**1100 Briar Hill Avenue - Zoning By-law Amendment
Application - Request for Direction Report**

Date:	July 22, 2014
To:	North York Community Council
From:	Director, Community Planning, North York District
Wards:	Ward 15 – Eglinton-Lawrence
Reference Number:	13 221087 NNY 15 OZ

Site Plan
 Applicant's Submitted Drawing

Attachment 1: Site Plan

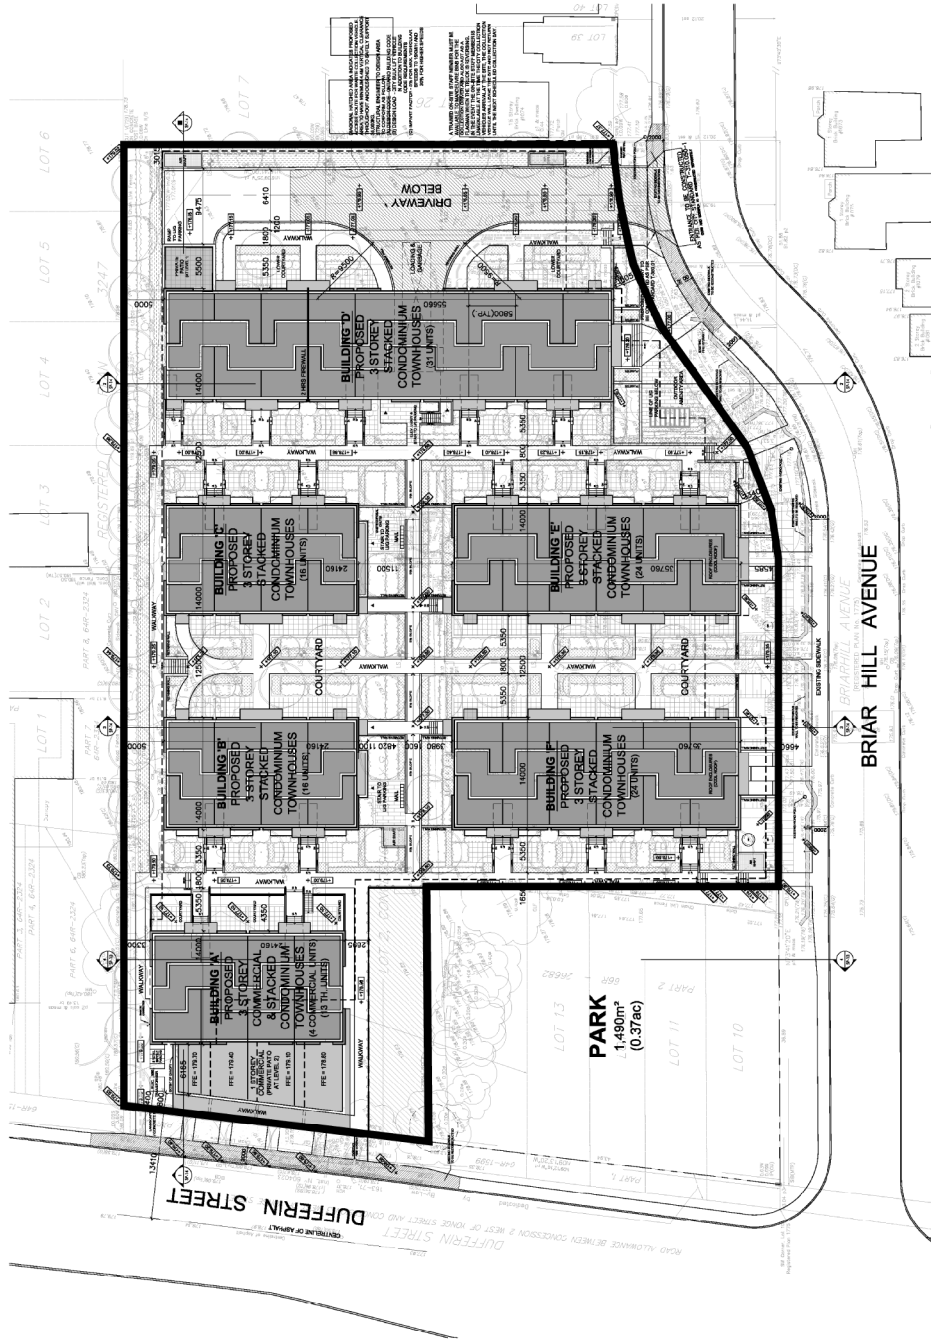
The five townhouse blocks that have been located perpendicular to Briar Hill Avenue are organized around a series of linear private open spaces 12.5 metres in width with pedestrian walkways ranging in size from 1.8 metres to 2.0 metres, extending from Briar Hill Avenue the full depth of the site to the north property line. This arrangement places a public walkway along the rear of the properties facing Stayner Avenue and results in inappropriate side to rear yard and front to rear yard relationships to neighbouring uses. The north-south driveway along the east edge of the property is proposed with pedestrian, vehicular, loading and garbage area access along the existing single detached house to the east, and without an appropriate width and landscape buffer this relationship is problematic. The proposed site layout, including the location of the park on the corner, also removes the majority of front entrances for the new development away from either Dufferin Street or Briar Hill Avenue and into interior private open spaces. Due to the depth of the lot, ranging from 61 metres to 81 metres, the resulting length of these linear private open spaces with pedestrian walkways that provide address and access to the interior townhouse units raises a number of issues concerning visibility, safety and access to interior units.

An east-west pedestrian walkway has been proposed at the midpoint of the site and at the north end of the site. The midpoint walkway cuts through the townhouse blocks and links the development to the north end of the new public park and the Dufferin sidewalk. Staff like this east-west walkway as it joins the units on site with the new park and Dufferin Street. Currently, this walkway is compromised by the proposed additional on-site parkland dedication, to be located on the north side of the park, and by the proposed grading, both of which limit the function and accessibility of this east-west walkway. The east-west walkway along the north end of the site is narrow and provides little room for appropriate planting and screening to the existing neighbourhood and places the public along the rear of houses to the north. Staff recommend that the mid-block focus should be on the central east-west connection, enhancing pedestrian movement and providing clear access and address deeper into the site as well as creating better access for emergency vehicles, moving vans and other drop-off functions. If this central organizing feature could be accomplished effectively, a minor connection at the north of the site would no longer be necessary.

The proposed on-site parkland dedication is to be located directly abutting the north side of the park. This raises a number of planning concerns. The proposed additional parkland further reduces the *Mixed Use Areas* and *Avenue* portion of the site and exacerbates the limited availability for development. Due to the placement of the on-site parkland dedication, there is no direct visual or pedestrian connection from the east end of the site to Dufferin Street which is an important element to site organization, connectivity and safety.

There is an existing grove of mature trees located along the bend on Briar Hill Avenue, approximately between Building F and the proposed driveway. Policy 2.3.1.5 of the Plan encourages environmental improvements, including the preservation of trees. The southern portion of Buildings D and E are located in such a way that will result in the removal of those existing mature trees. Providing a large setback for Blocks D and E would allow for the preservation of the mature trees and the surrounding open space would reinforce the streetscape along Briar Hill Avenue and would result in a better fit of this new development with the existing context. Should the existing park and required additional lands for on site parkland dedication be relocated further into the interior of the site, on Briar Hill Avenue, it would be possible to preserve the existing grove of trees and preserve open space in the Neighbourhoods designation.

and automobile repair shop, are also found along the remainder of the north property line closer to Dufferin Street. Appropriate transition and setbacks should be provided to these differing adjacent uses and the new townhouse development, to ensure that light, views and privacy impacts are reduced. The proposed setbacks along the north property line of 3.3 metres to Block A and 5 metres to Blocks B, C and D should be increased to provide appropriate separation distances between the new development and adjacent uses. In addition, the proposed 3.1 metre setback to the driveway along the east property line, and associated loading and servicing functions found along this driveway should be increased to provide for appropriate space to ensure these functions are screened by landscaping from adjacent neighbours.
